Proposed Wind Energy Facility and Associated  
Infrastructure on Wolf Wind Farm (Pty) Ltd, near  
Wolwefontein in the Eastern Cape

22 July 2020

DEA Reference:  
14/12/16/3/3/2/599/AM5

Final EA Amendment Report

**Figure 3-3 | Comparison between approved vs proposed changes to the turbine envelope.**

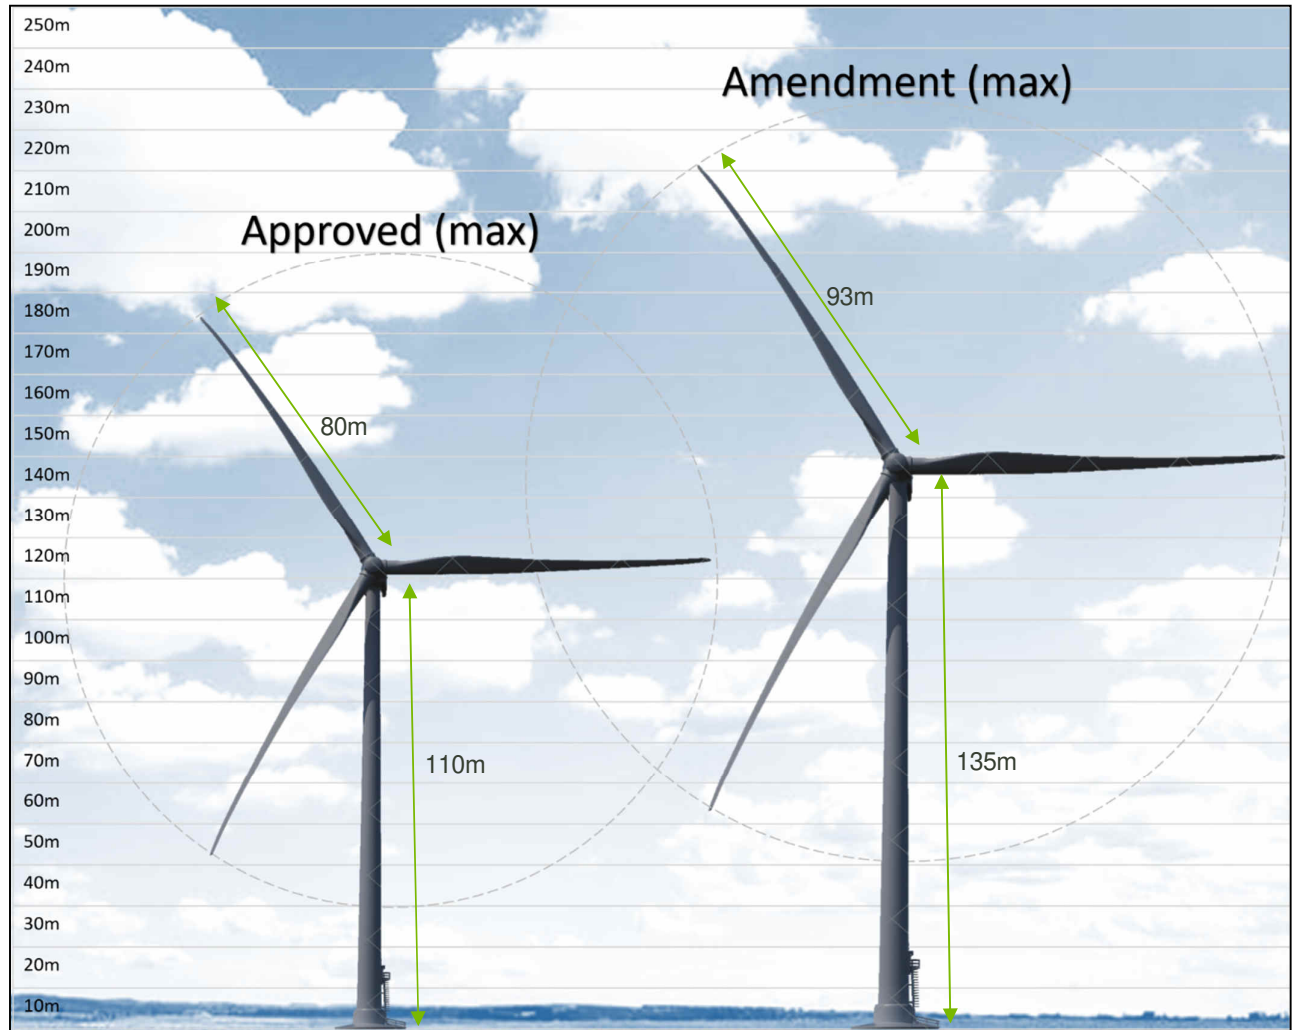
1. **Tower height:** Increase turbine tower height from  $\leq 110\text{m}$  to  $\leq 135\text{m}$
2. **Rotor diameter:** Increase max Rotor diameter from  $\leq 160\text{m}$  to  $\leq 186\text{m}$

**Figure 4-1 | Proposed changes to layout vs NSDs**

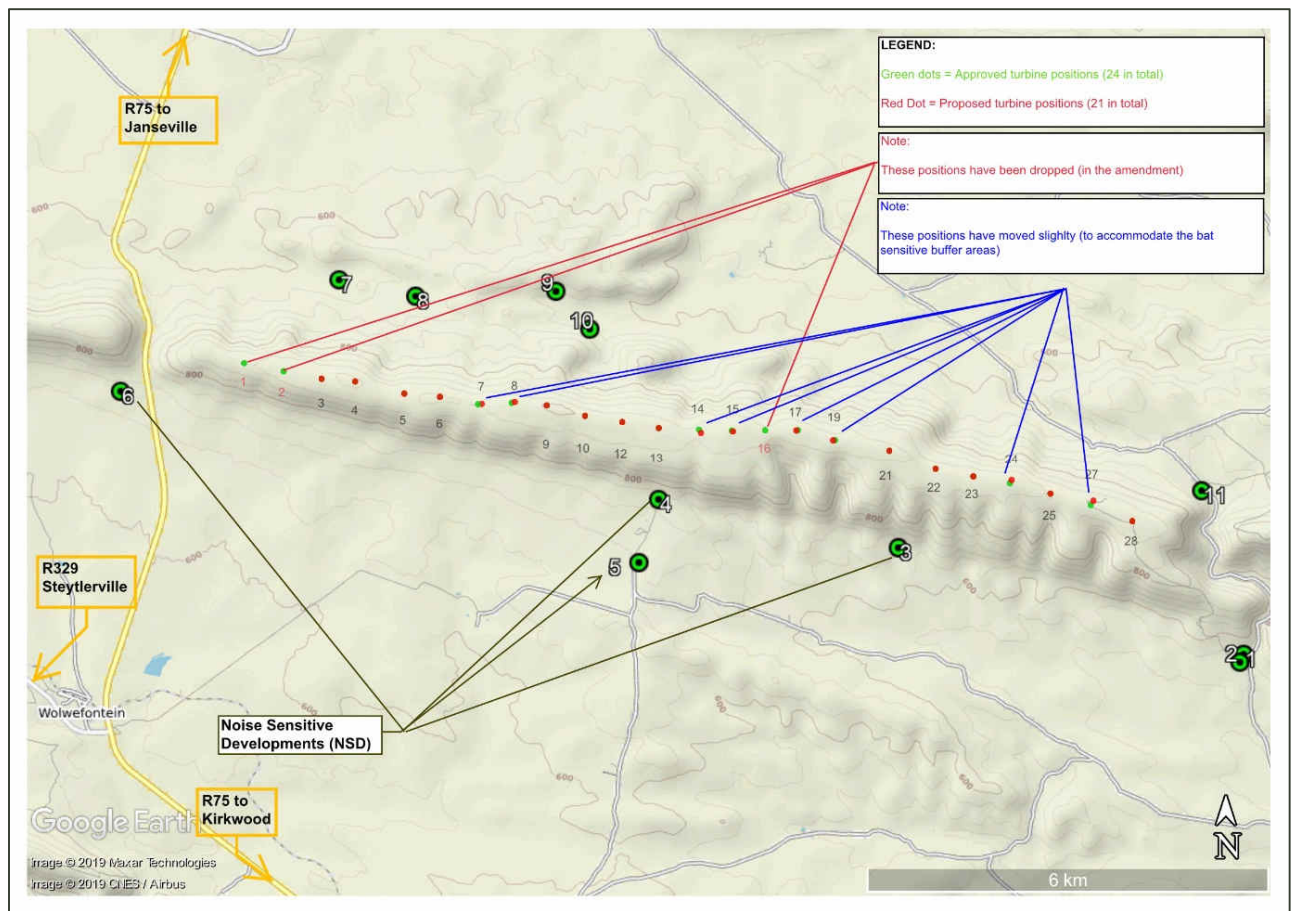
Wolf Wind Farm (Pty) Ltd is seeking approval to increase the rotor diameter from the approved 160m to ≤186m (proposed amendment) and the turbine tower height from 110m to ≤135m. With larger turbines the number of turbines positions being applied for decreases from 24 to 21 (max), although even fewer are likely to be constructed— layout depicted in Figure 4-1. Turbine positions 1, 2 and 16 have been ceded in this amendment. Also, to better avoid bat buffers with the larger turbine blades, eight turbines have been moved slightly or micro sited (see map on overleaf).

These changes are unlikely to affect the noise impact profile and the findings of the original Environmental Noise Impact Report since the distance between the various NSDs and the nearest turbines are not affected by the changes, with the exception of NSD06 who is now further away, but was originally assessed to receive a “very low (-)” noise impact, and the changes are unlikely to affect this finding or the overall impact profile.

Figure 4-2 | Viewshed increase due to proposed amendments

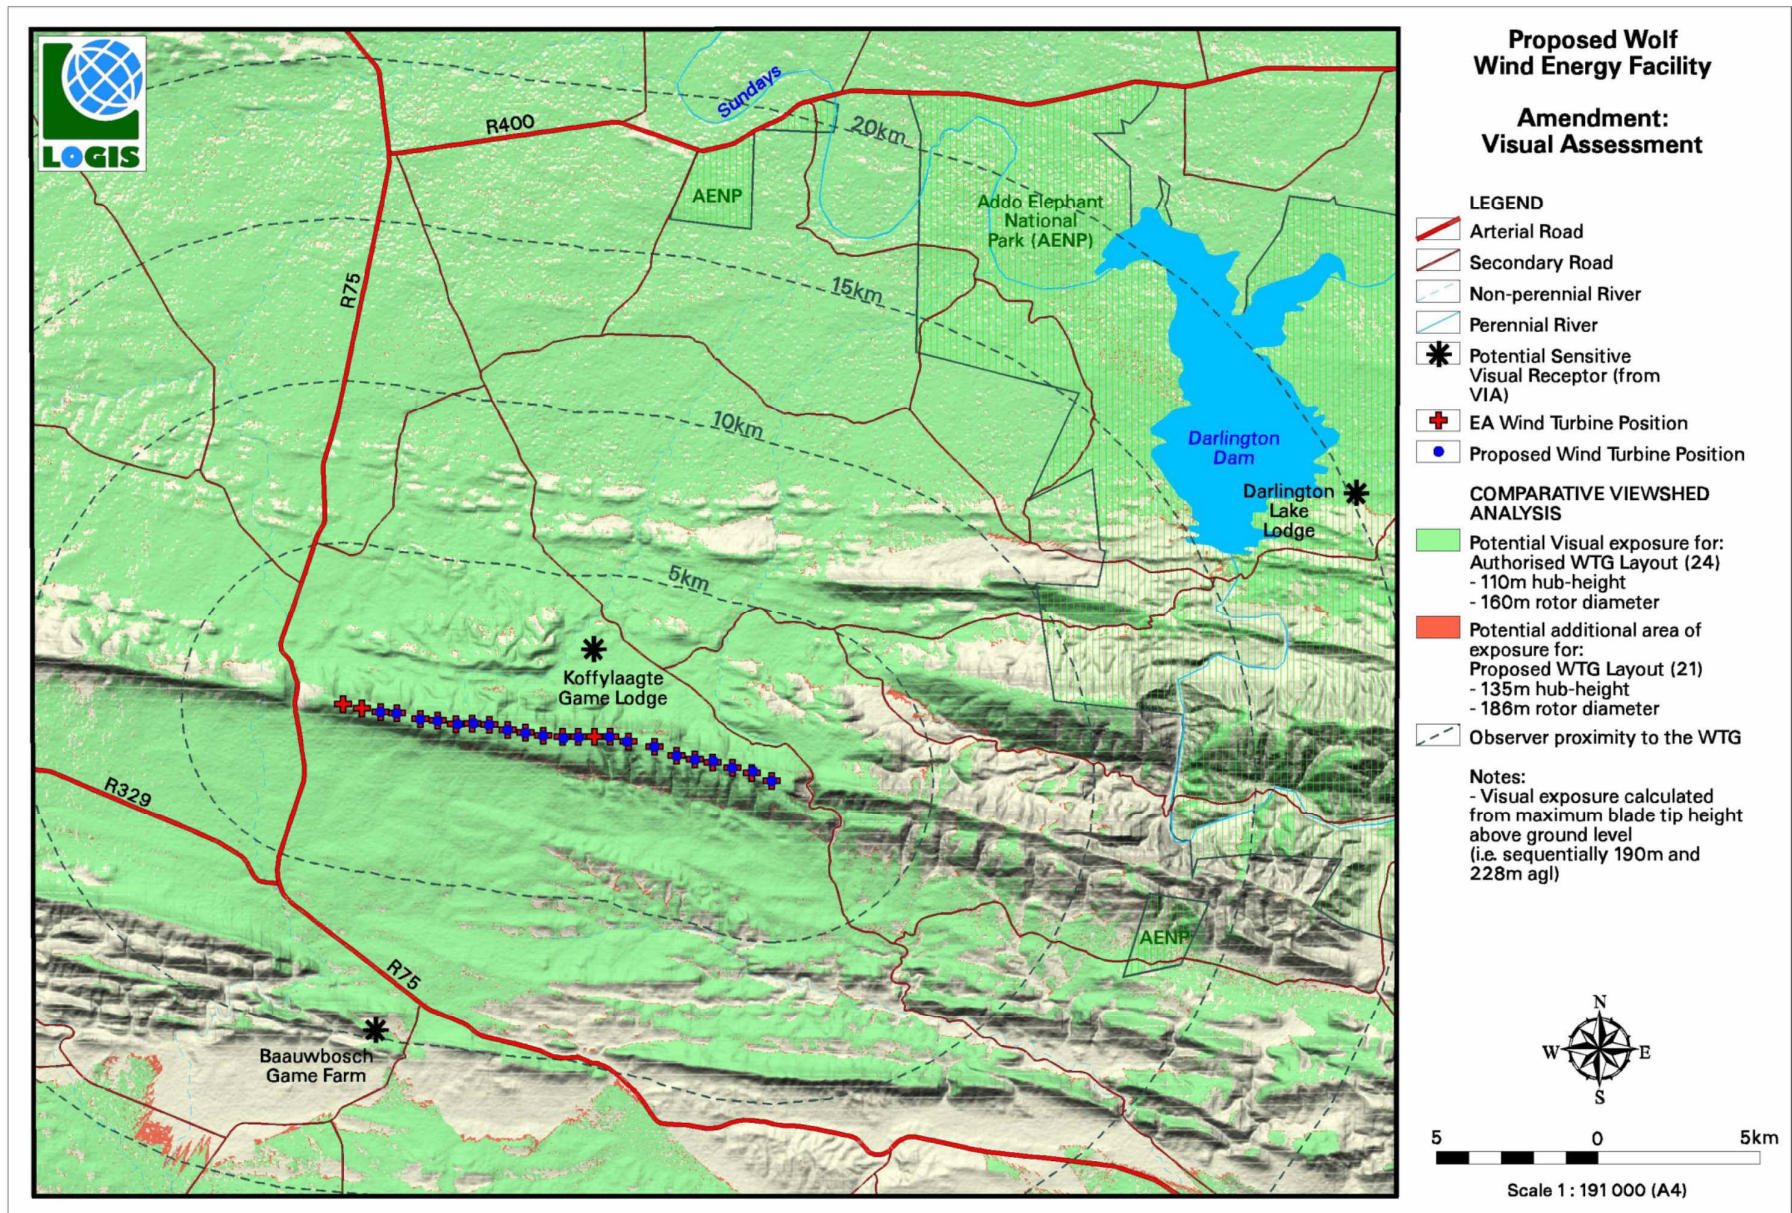
A comparative viewshed was compiled which shows the affected areas of the approved project in green and the additional affected areas, due to the proposed amendment, in red. This reveals the amendment will have a marginal increase of viewshed.

The ~17% increase in total turbine dimensions results in a ~2% increase in visual exposure. Within the 2% there are no additional sensitive visual receptors located within a 20km radius of the turbines that would be affected. Nor are there any additional major roads affected by the amendment.

**From a visual perspective, the proposed changes to the turbine dimensions and turbine layout will not alter the nature or scope of the visual impacts and therefore require no (zero) change to the significance rating within the original Visual Impact Assessment Report that was used to inform the approved EIA and the subsequent amendments thereafter. In addition to this, no new mitigation measures are required.** Consequently, the visual impact (significance rating and profile), as stated in the original VIA report, remains unaffected by the proposed amendments and no additional impacts, mitigation measures or alterations to the EMP are required.

**Figure 4-3 | Bat sensitivity map with increased high sensitivity buffers. White dots = proposed 21 turbine layout base locations; Solid red = high bat sensitivities; Opaque red = 200m high bat sensitivity buffer; Yellow = moderate bat sensitivities.<sup>8</sup>**

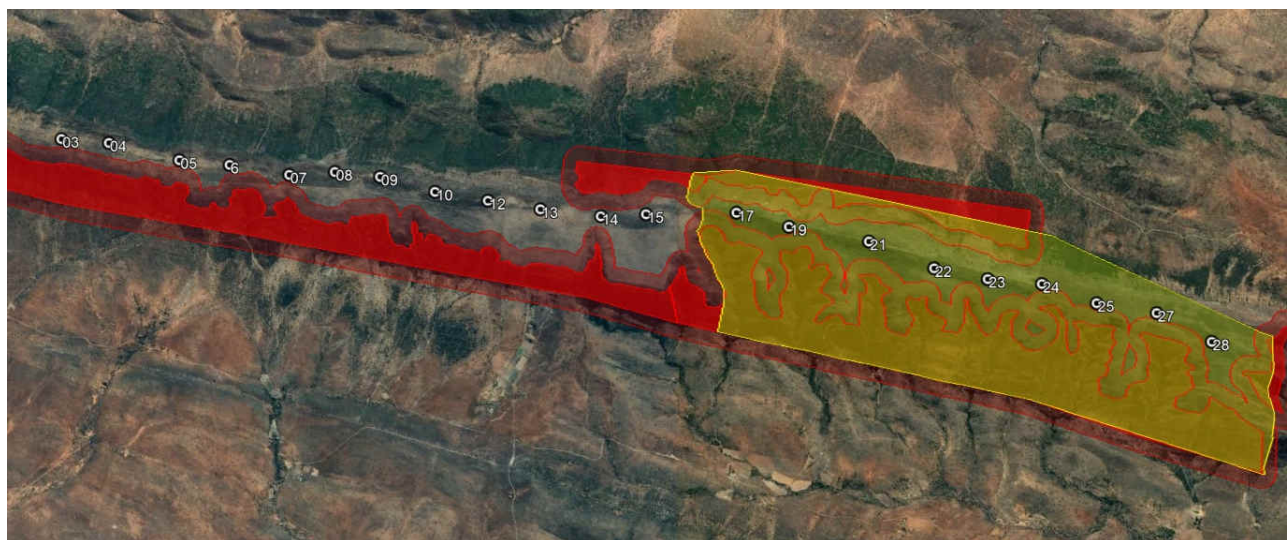
Due to recent insights regarding necessary buffer distances for high bat sensitivities, the buffer distances of the bat sensitivity map were revised upwards from 150m to 200m, to align with the latest South African Good Practice Guidelines for Surveying Bats at Wind Energy Facility Developments - Pre-construction: Edition 4.1. (Sowler, et al., 2017). The reduction of the number of turbines as well as micrositing of turbine positions by the applicant respects and accommodates the updated bat sensitivity map. Figure 4-3, illustrates the updated high bat sensitivity buffers, in relation to the proposed amended turbine layout.

The micro-siting of 8 turbines in the proposed layout, as well as the reduction in the number of turbines (from 24 to 21), respects the revised bat sensitivity map and may further decrease the risk of impacts on bats. It's also likely that larger and more efficient turbine models may be available in future, further reducing the number of turbines installed. In such event, from a bat perspective only, the turbine positions that should be sacrificed from the layout in order of preference are as follows: Turbines 27, 28, 24, 05, 07, 14 and lastly 19 (thereafter, from, east to west).

Animalia has reviewed the proposed amendment, and all the assessment of impacts as well as the mitigation measures specified in the EIA phase bat assessment and preconstruction study remain unchanged by the proposed amendment. Even though in a broader spectrum, the proposed amendments may reduce the risk of impacts on bats, which is seen as generally positive, however the reduced risks are **not sufficient enough to change the impact significance ratings or recommended mitigations determined of the original study**. The proposed amendments are acceptable from a bat sensitivity perspective.

**Figure 4-4 |Indicative diagram of the original and proposed rotor swept areas (not to scale).**

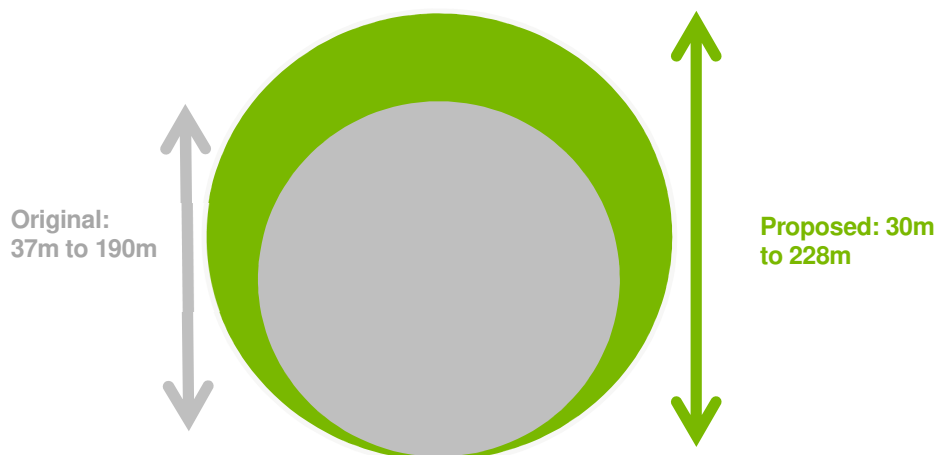
However not all factors are equal. As illustrated in Figure 4-4 below, since the lower tip height of the proposed new rotor remains relatively unchanged, most of the change in rotor swept area comes at the upper blade tip, which is above the height at which we record most bird flights. None of the priority species recorded flying on site had average flight height anywhere near the upper blade tip height of 190 to 228m (See Table 4-1). Thus, increases at the upper altitudes will not increase the collision risk.

**Figure 4-5 | Cumulative change in rotor swept area (WCS).**

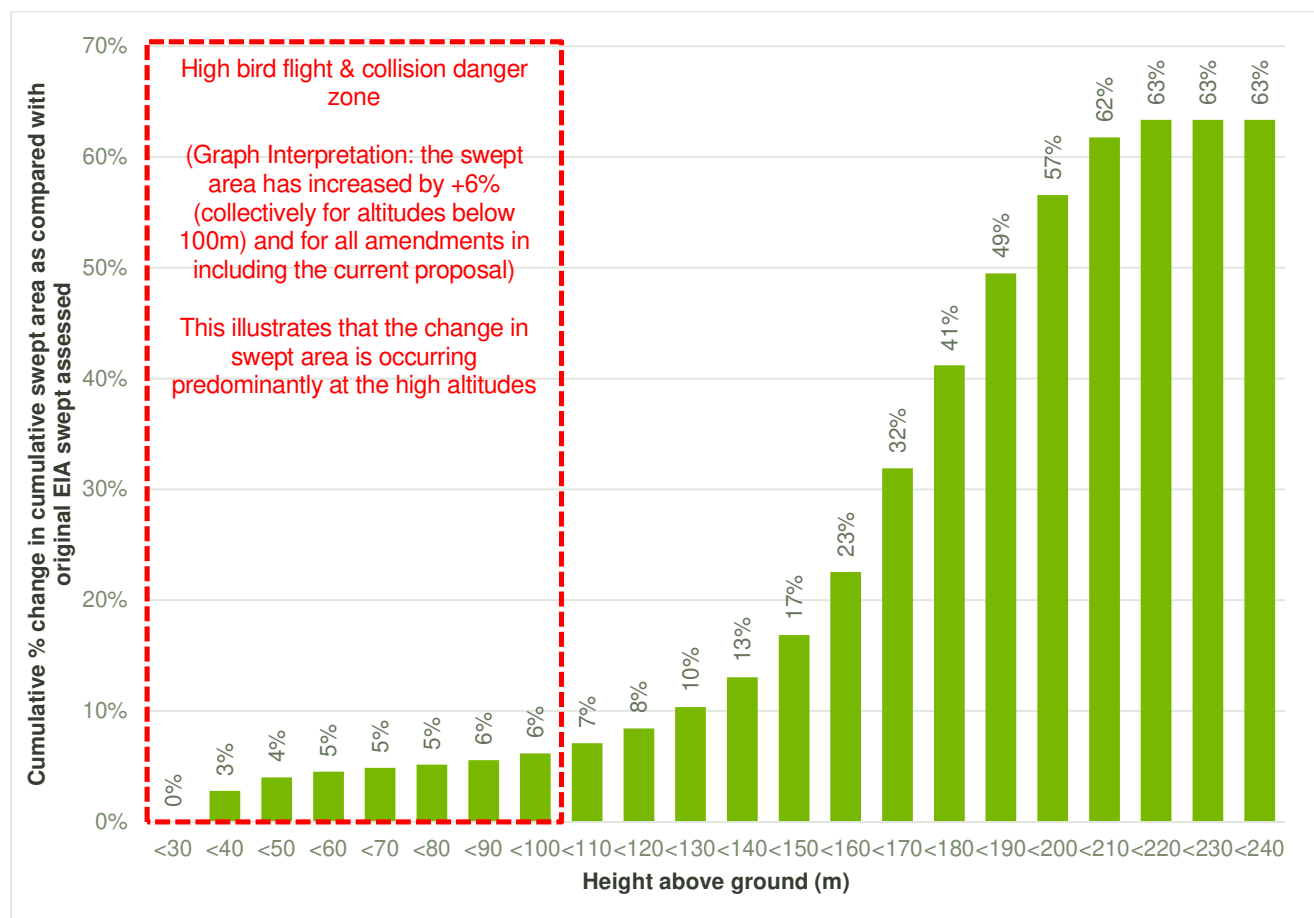
10m increments) as shown in Figure 4-5. This figure can be interpreted as follows: below 80m (where most recorded bird flights took place) the total change in swept area has increased by 5% (for all amendments) as compared with the assessed original. Below 150m, the total cumulative increase would amount to 17%. In other words, at the heights that we recorded relevant bird species flying, the increase in rotor swept area is fairly low when compared to the assessed original. To illustrate this, the area below 100m altitude (or 80m plus a precautionary 20m) has been marked as the high collision zone, and here we only see a cumulative 6% increase in swept area in this zone over the assessed original, despite there being a cumulative 63% increase overall.

We conclude then that the actual realised increase in collision risk to the relevant bird species flying on the Wolf site as a result of the current proposed amendment, considered together with the previous amendments, will not be sufficient enough to increase the significance rating from Medium (-) when considering the Worst-Case Scenario.

**Figure 4-6 | Bird sensitive areas vs approved vs planned turbine layout**

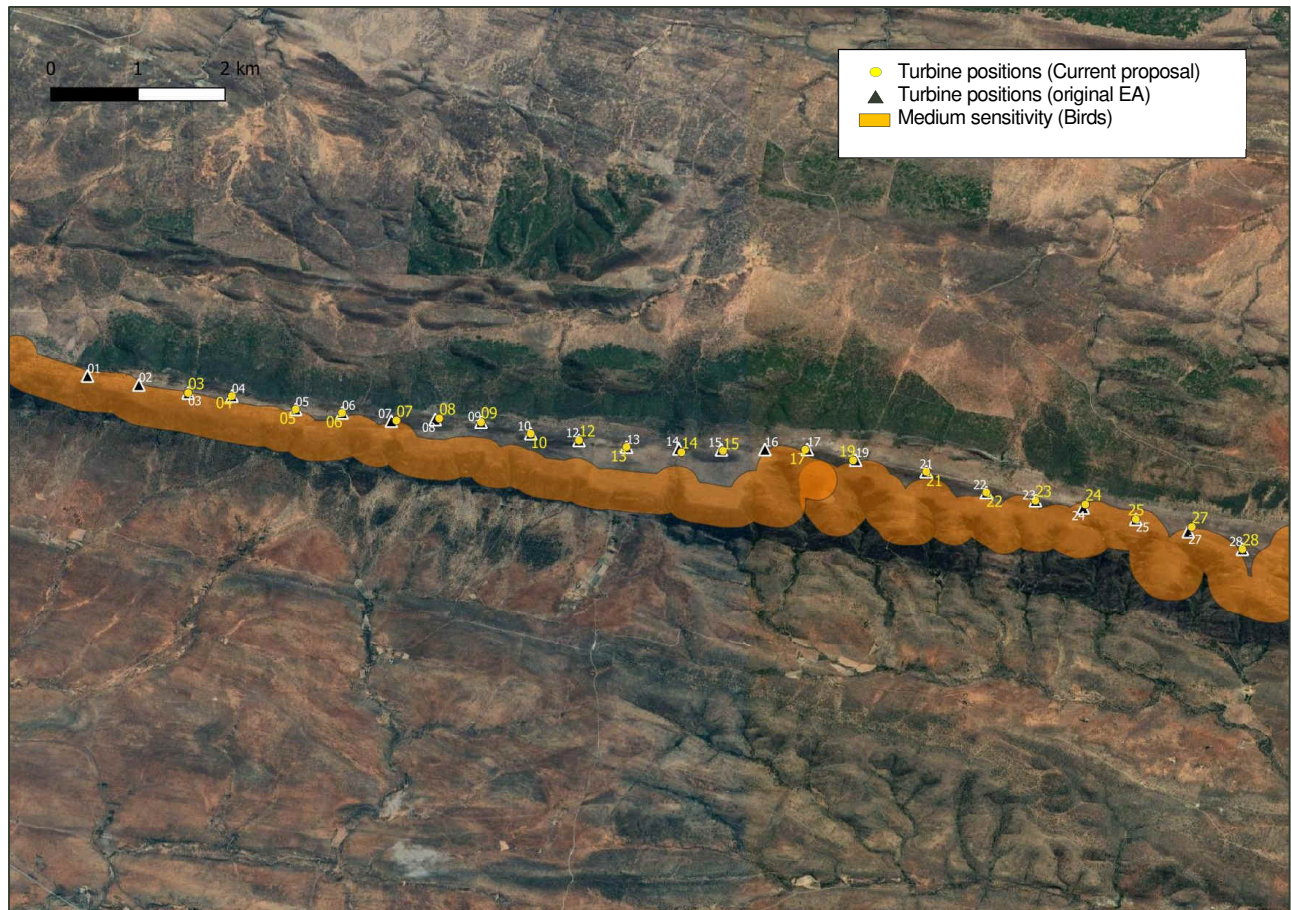
- No turbines, other than numbers 24 and 25, should impinge the MEDIUM sensitivity areas identified by this study (these are shown in Figure 4-6 to follow). Where necessary this can be discussed further with the specialist and agreement reached.
